Re: Groton Wind Farm, Revised Site Plans
SEC Docket No. 2010-01
Wetlands File No. 2010-00745
Alteration of Terrain Permit No. 100325-033

Project Revisions
Index Sheet

Project Revisions
 Sheet 1 of 2

Project Revisions
 Sheet 2 of 2

Existing Conditions
Drainage Area Map
Operations & Maintenance Building
Groton Hollow Road
Groton, New Hampshire

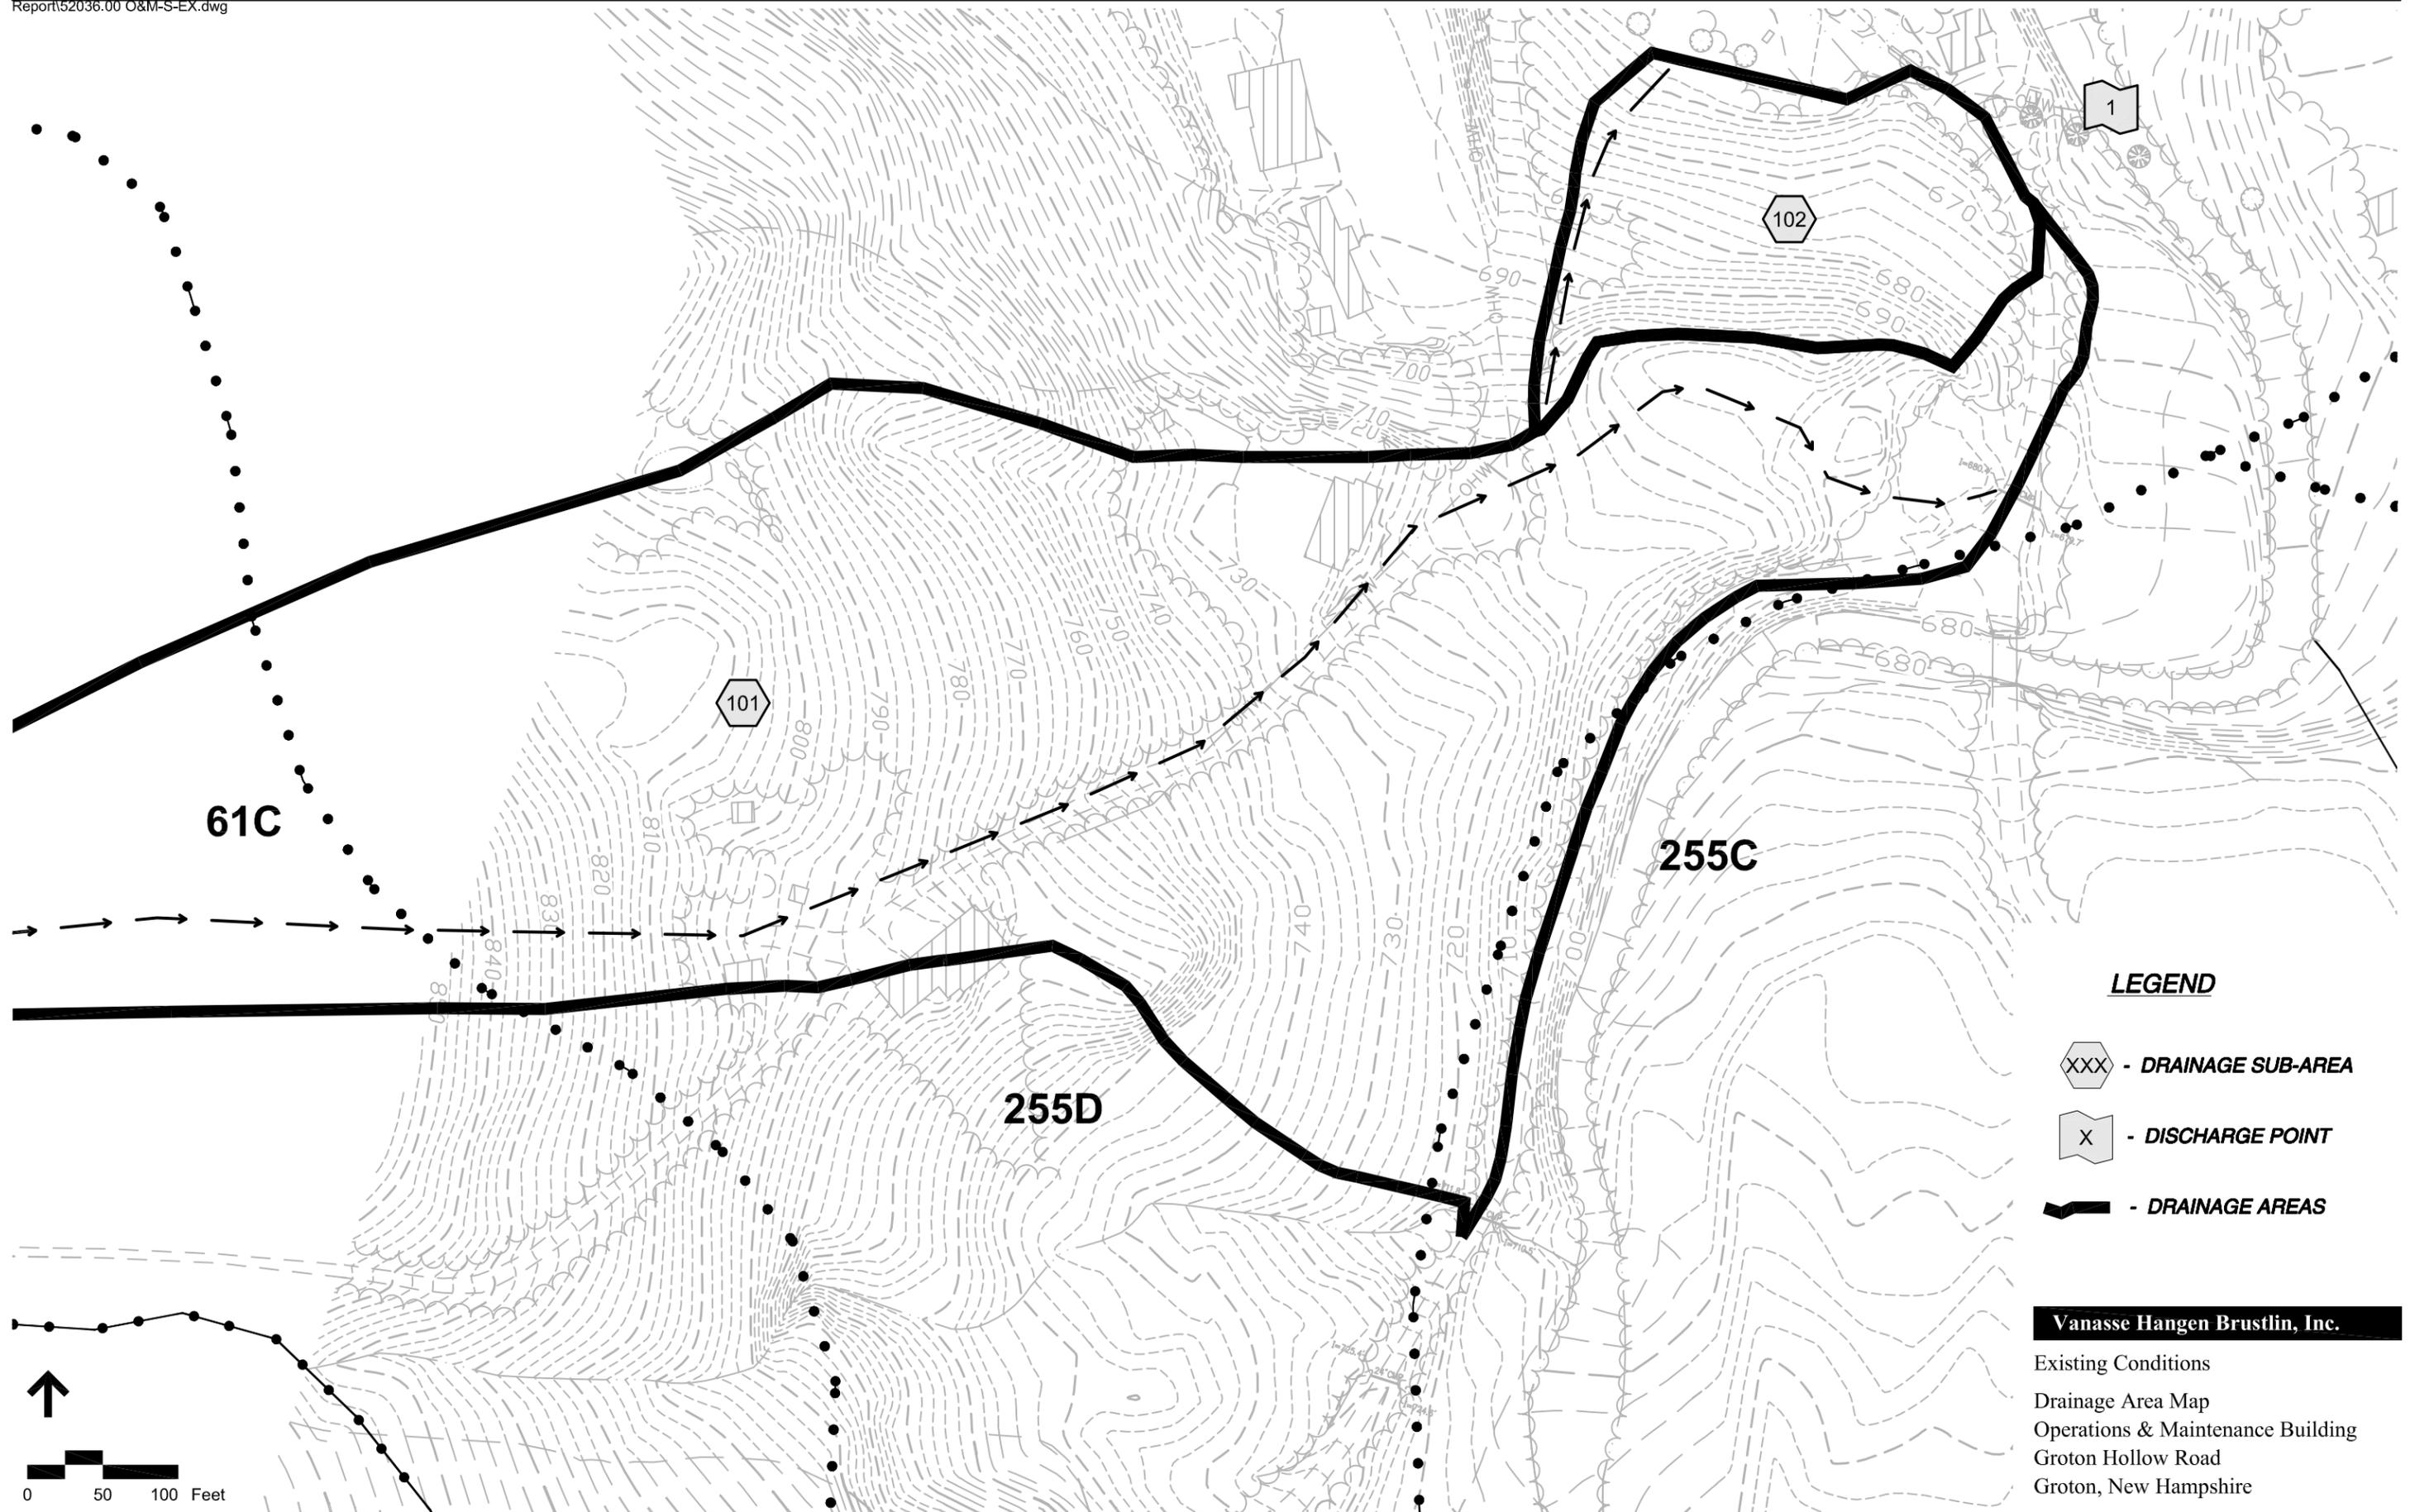
The O&M building was moved from the east side of Clark Brook to the west side of Groton Hollow Road to a location where a fenced in switch yard was previously proposed. In addition, the total area for the O&M building and adjacent storage area has been reduced. Refer to Drawing C-3.1 for a plan showing the revised layout of the O&M area. This change has several environmental advantages:

Operations & Maintenance Area

Condition	Peak Runoff Rate (cfs)			
	1-yr	2-yr	10-yr	50-yr
Existing	0.18	0.53	6.65	14.94
Proposed	0.18	0.28	4.26	14.80
Net Change	0.00	-0.25	-2.39	-0.14

Proposed Conditions
Drainage Area Map
Operations & Maintenance Building
Groton Hollow Road
Groton, New Hampshire

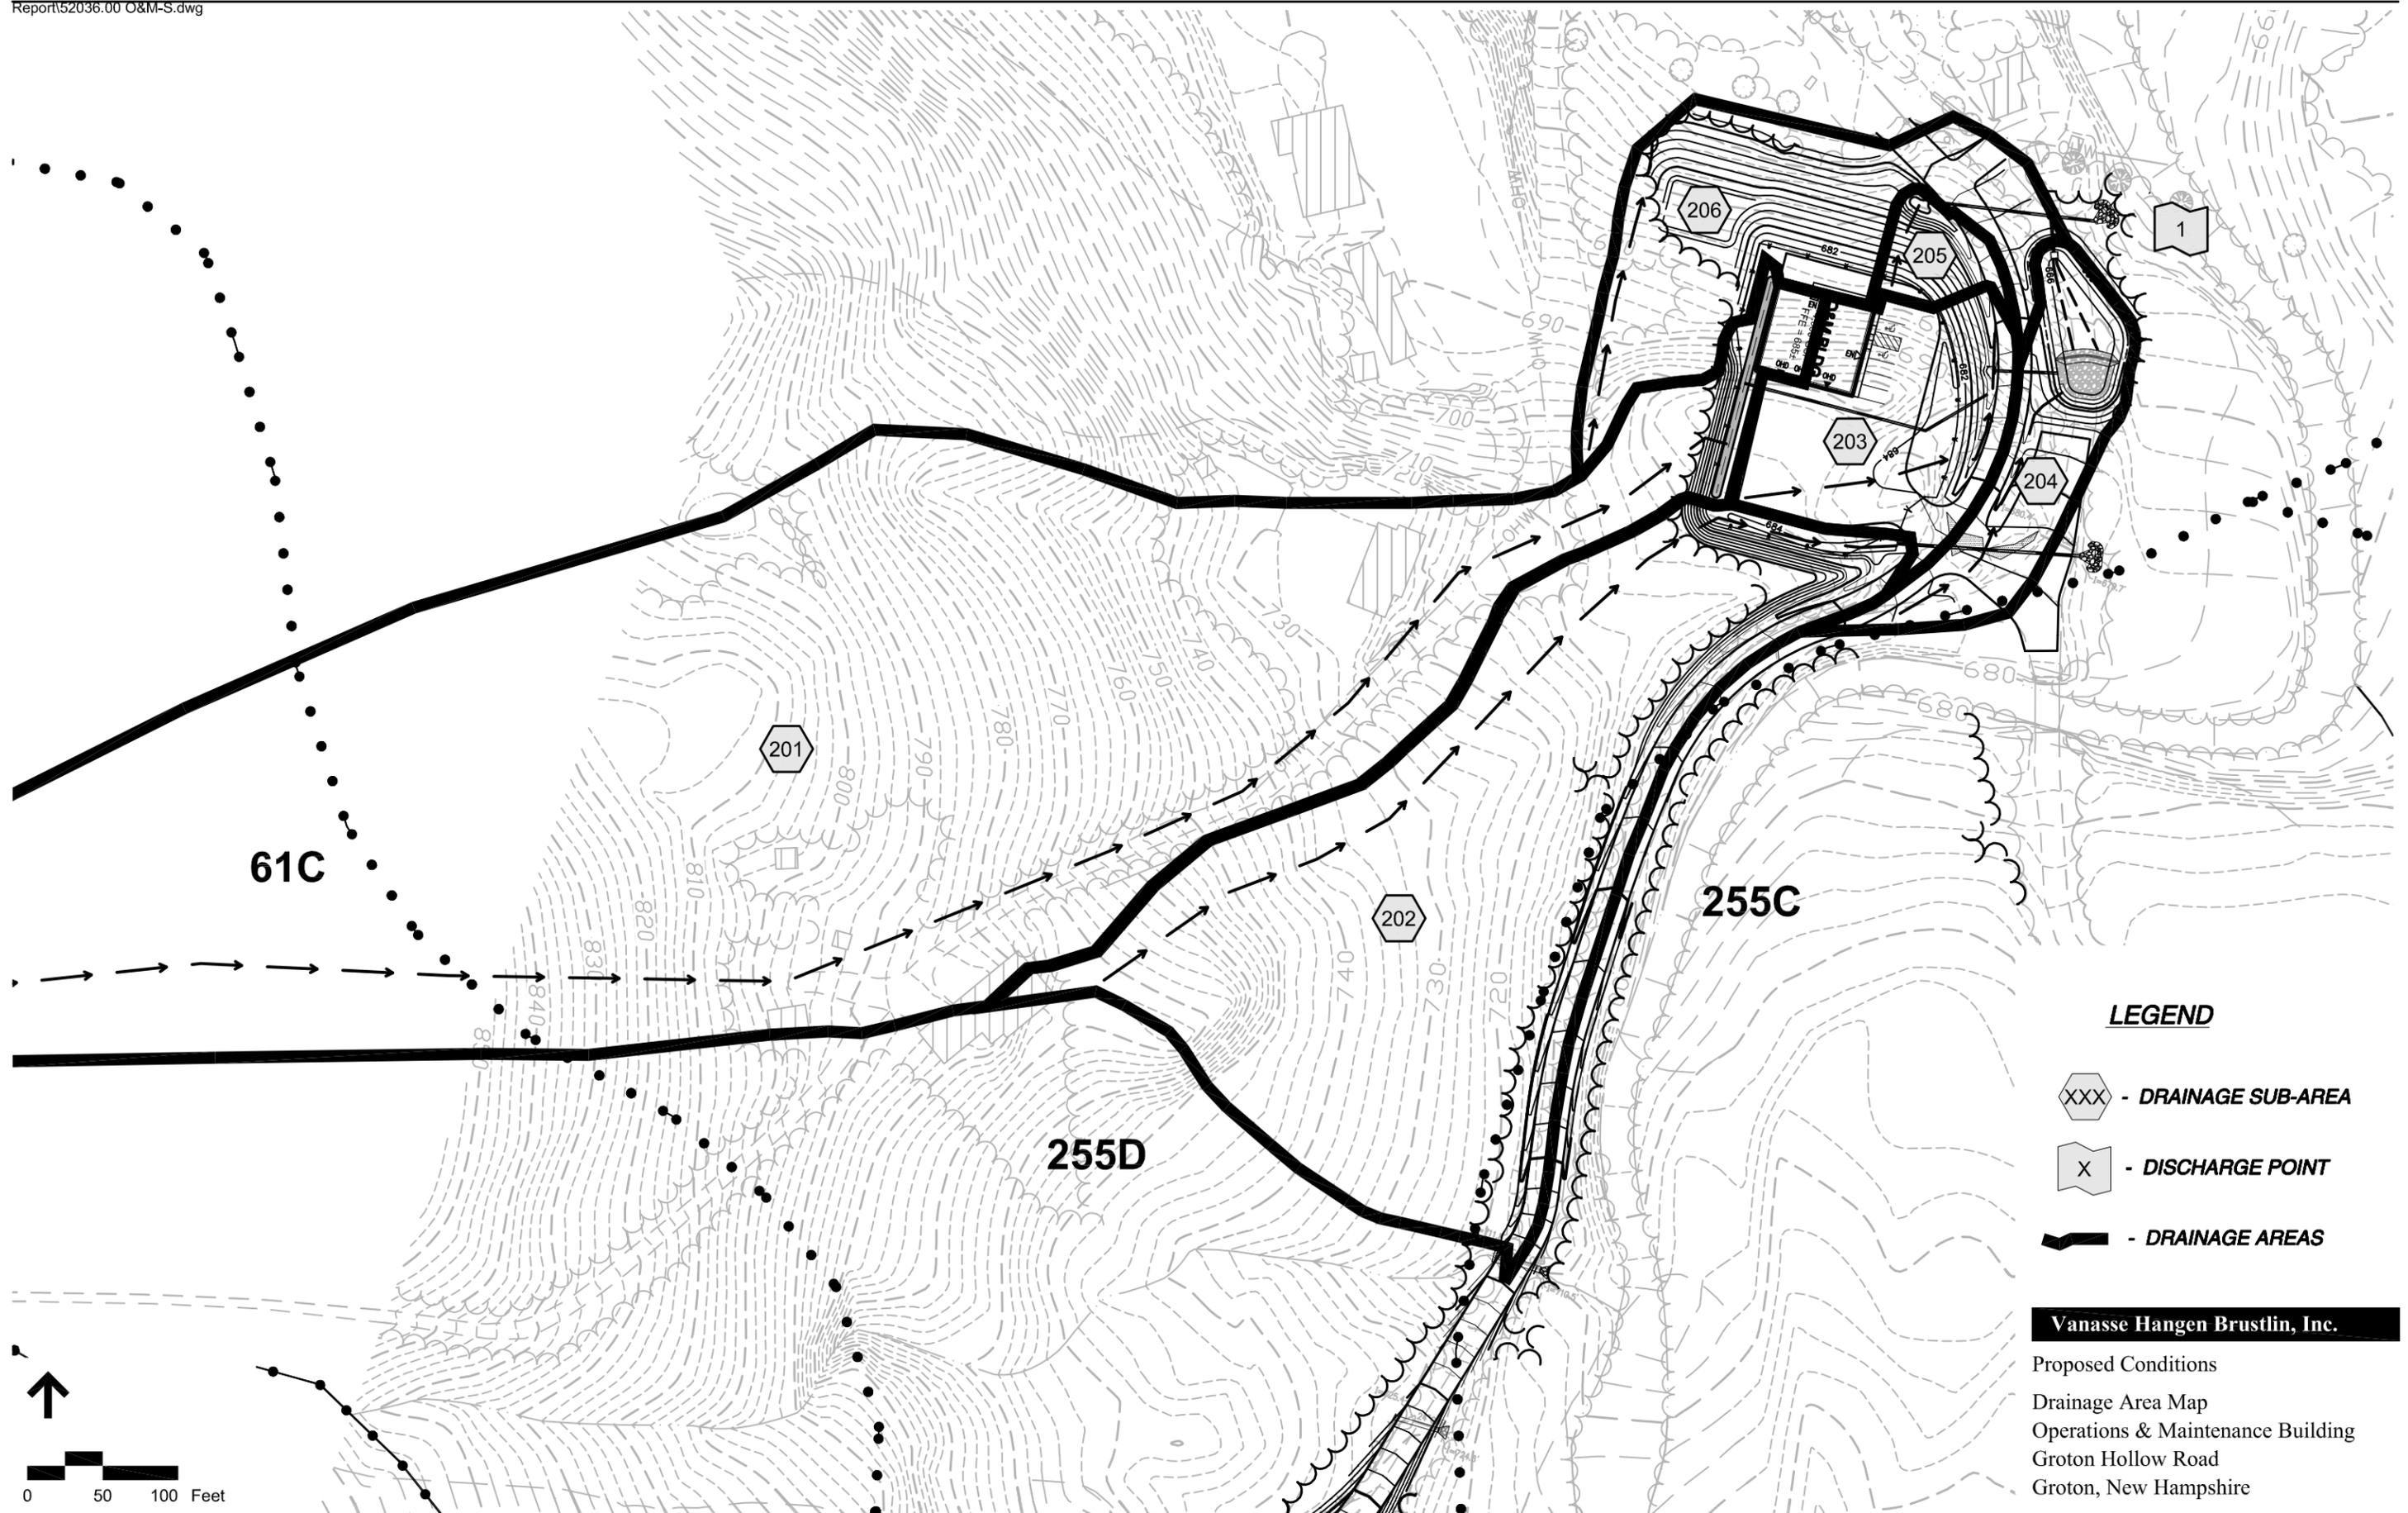
The stormwater management design for the relocated O&M building is based on the stormwater BMP's that were proposed for the original location and approved by the NHDES through New Hampshire's SEC process. Stormwater treatment will continue to be provided by a filtration basin (with sediment forebay) as previously proposed. The filtration basin will also serve to help maintain peak runoff flow rates from the O&M building area.
